**SUBJECT: NOTICE OF DEFECIENCY**  
**FINAL RCRA FACILITY INVESTIGATION REPORT ADDENDUM FOR**  
**MELROSE BOMBING RANGE**  
**CANNON AIR FORCE BASE, NEW MEXICO**  
**EPA ID NO. NM5572124456-1**

The New Mexico Environment Department (NMED) has reviewed the *Final RCRA Facility Investigation Report Addendum for Melrose Bombing Range* (Addendum ) dated February 2003 along with the *Phase I RCRA Facility Investigation for Melrose Air Force Range Draft* Volumes I and II (Drafts) dated October 1999. NMED has determined that Cannon Air Force Base (CAFB) Drafts and Addendum are technically deficient. The following issues must be addressed:

**FIGURE 2-5 AOC-1 SITE MAP**

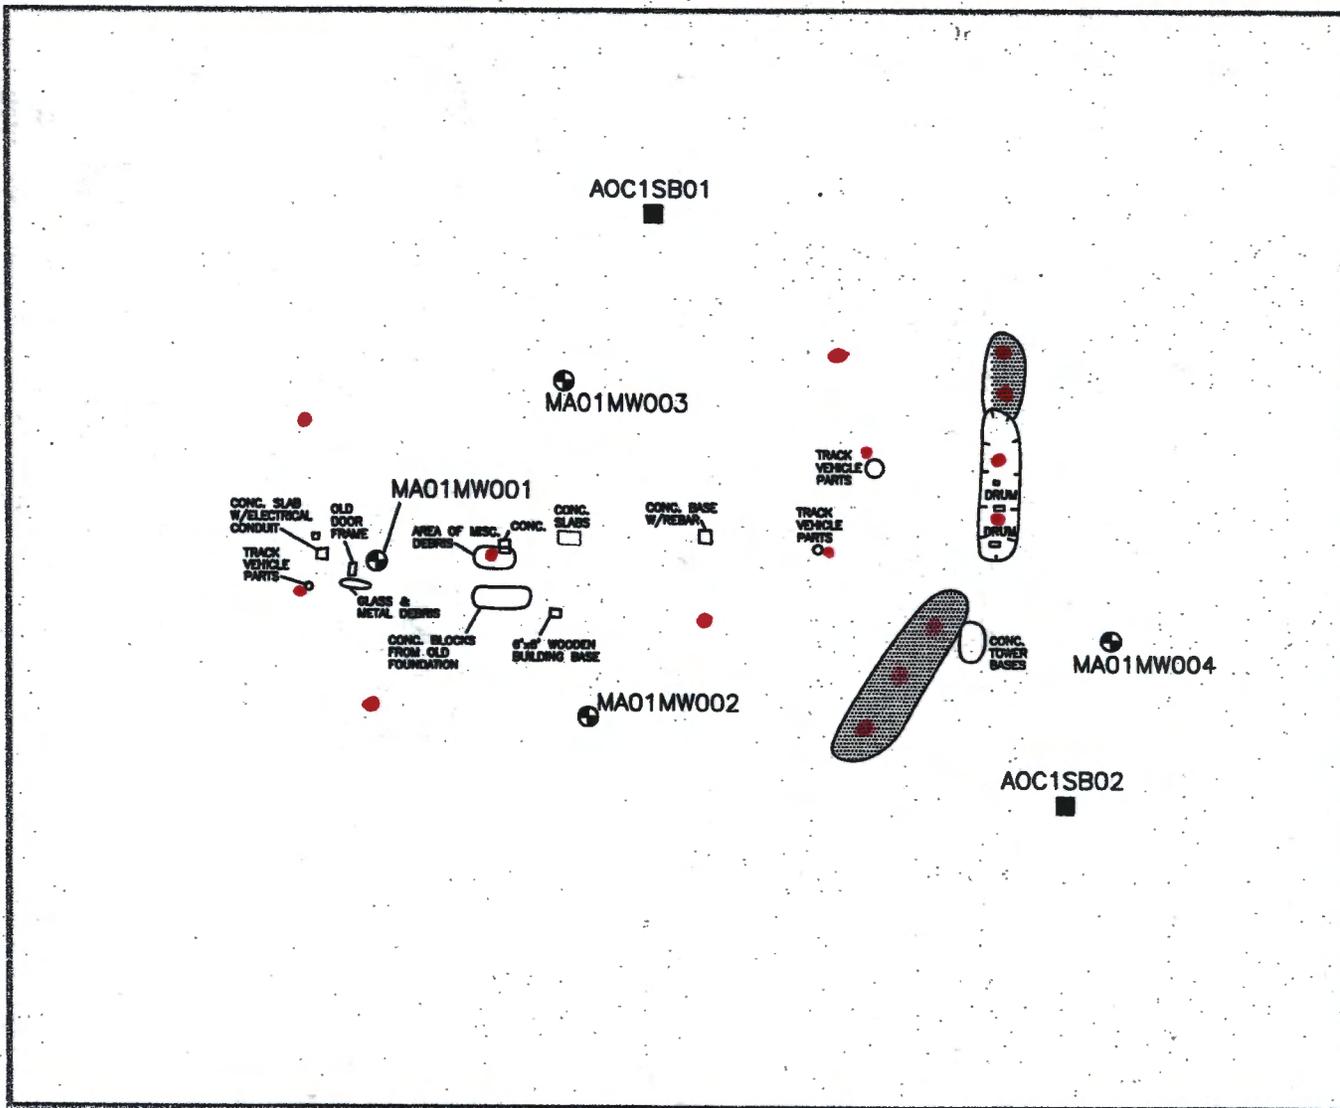
NMED is concerned that AOC 1 has not been adequately characterized with respect to surface soil.

AOC 1 consists of approximately 23 acres; however, only six surface soil and shallow subsurface soil samples were collected at the site. In addition, it does not appear that any biased sampling was conducted. Based on the review of Figure 2-5, mounded areas, depressions, drums, and other obvious remnants of past activities were observed at the site. The sampling did not address any of these areas. Discuss why sampling in and/or around the mounds, depressions, and drums was not conducted. Also discuss the impact of this lack of characterization on the ecological risk assessment.

**Recommendations:** NMED requires submittal of a work plan for further investigation at AOC 1. The work plan shall include soil field screening, visual inspection of debris, and collection of soil samples from the mounds, depression, miscellaneous debris areas, and around the locations of the discarded truck vehicle parts. At a minimum, two samples from the depression, one at each of the truck vehicle parts locations, one sample at the miscellaneous debris area, and four samples in the vicinity of the activities area (as marked in the Figure 2.5 of this letter) shall be collected. Samples collected from the depression shall be analyzed for RCRA metals, volatile organic compounds (VOCs) (SW-846 EPA 8260), diesel range organics(DRO) and explosives. All other samples shall be analyzed for DRO, RCRA metals and explosives. The work plan shall also include descriptions of mounds and depression, including sampling location maps and pictures. Samples from the mounds shall be collected only if the mounds are identified as containing debris. A map of the recommended sampling locations is attached.

<b>FOSTER WHEELER ENVIRONMENTAL CORPORATION</b>	
DATE: 04/09/02	<b>FIGURE 2-8 AOC-2 SITE MAP</b> <small>U.S. ARMY CORPS OF ENGINEERS, OHAMA DISTRICT WHEELER TRAINING RANGE CANNON AIR FORCE BASE</small>
SCALE: 1:40	
DRAWN: REP

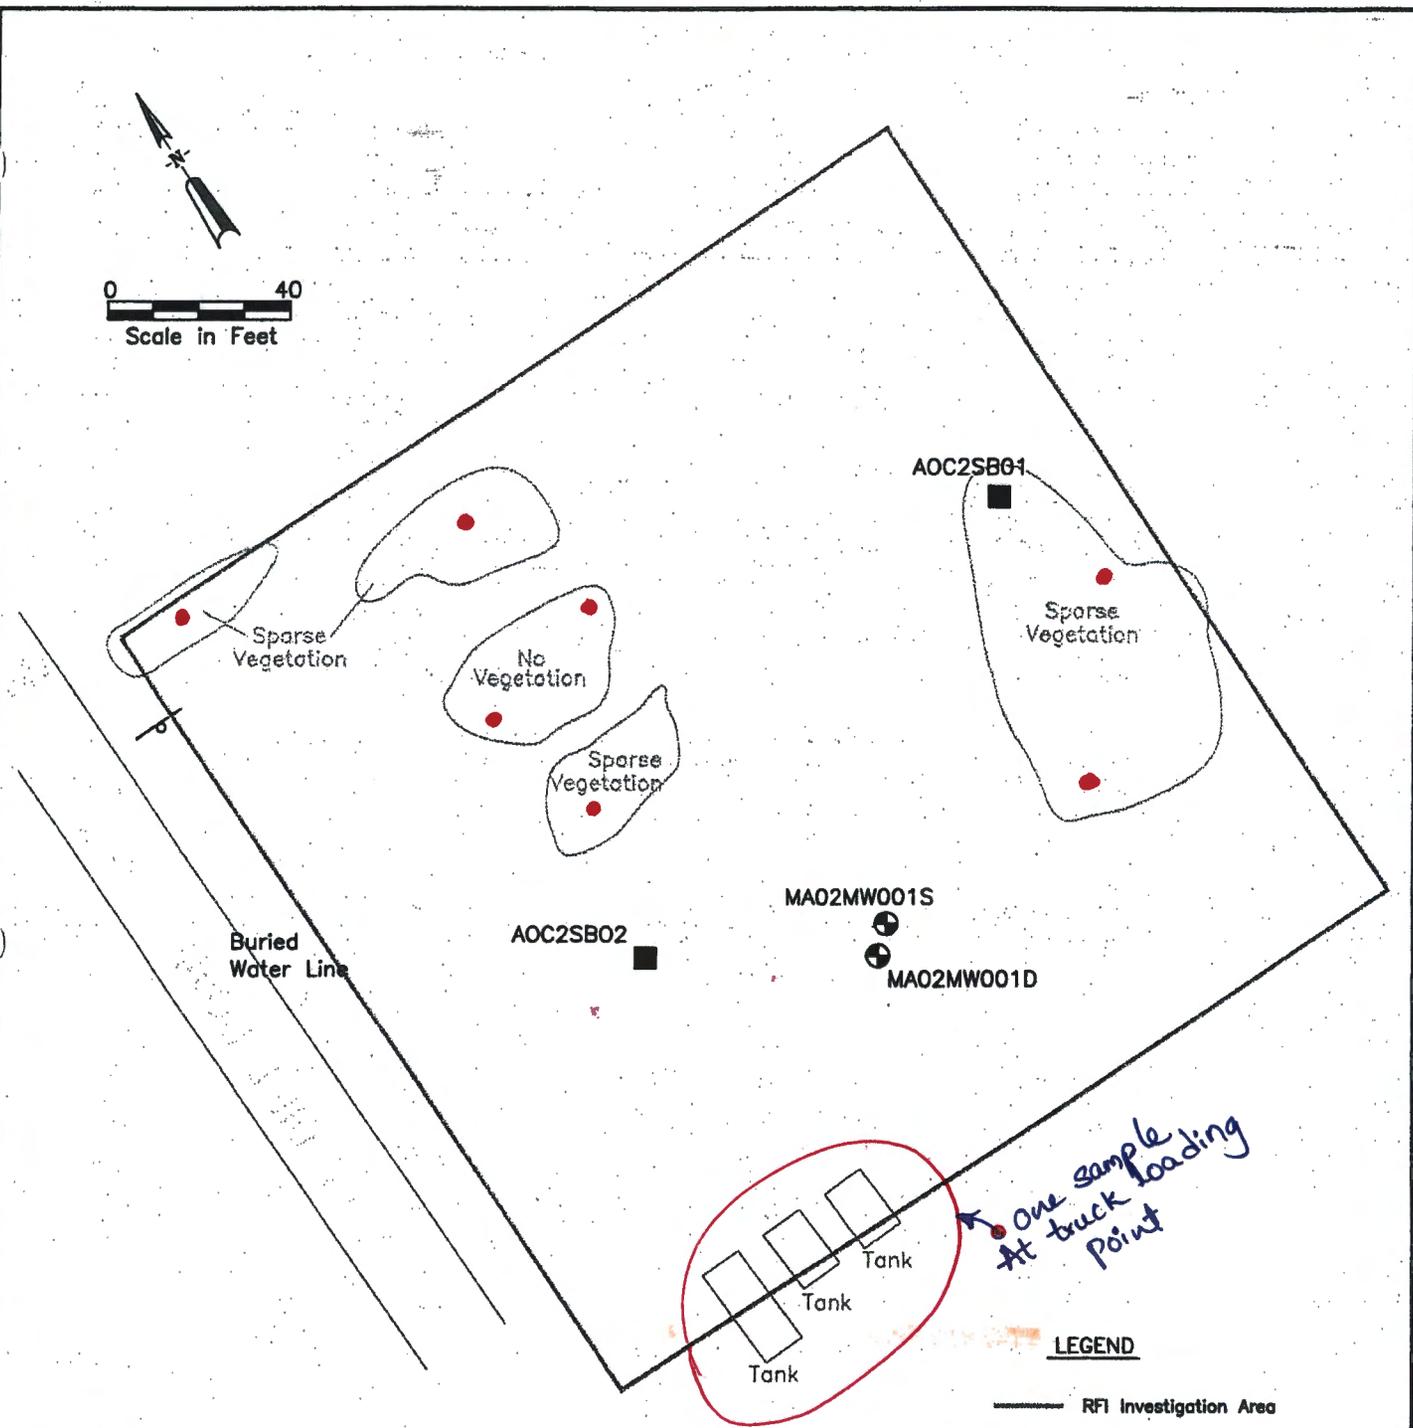
NMED is concerned that AOC 2 has not been adequately characterized with respect to surface and near-surface soils.

Only four surface soil and shallow subsurface soil samples were collected and analyzed to characterize site conditions at AOC 2. Upon reviewing Figure 2-6, there are three tanks and several areas of sparse or no vegetation at the site; however, it does not appear that any sampling of soil in and around these areas was conducted. Typically areas of dead or disturbed vegetation are indicative of past activities and potential waste disposal sites. This appears to be a major data gap.

**Recommendations:** NMED requires submittal of a work plan for further investigation at AOC 2. The investigation shall include soil field screening and visual inspection of debris. An

Investigation report shall identify the type of fuel stored in the three tanks and, if unknown, analysis to identify the fuel types shall be completed and documented. The report must also include photographs of the tanks, including the area beneath and around the tanks and documentation of any leaks/staining. If there is evidence of a leak, the stained soil shall be sampled and analyzed for the compounds consistent with those stored in the tanks. Test pits approximately 6 to 10 feet deep shall be excavated at AOC 2 at the locations of the sparse or absent vegetation to check for waste. Two samples from the east sparse vegetation area, one from each from the other three sparse vegetation areas, two from the area where vegetation is absent, and one sample from the truck loading area near the fuel tanks shall be collected. All soil samples collected from these areas shall be analyzed for RCRA metals, VOCs (EPA 8260), semi volatile organic compounds (SVOCs), polychlorinated biphenyls (PCBs), dioxins and furans. A map of the recommended sample locations (test pits) is provided in Figure 2-6 of this letter.
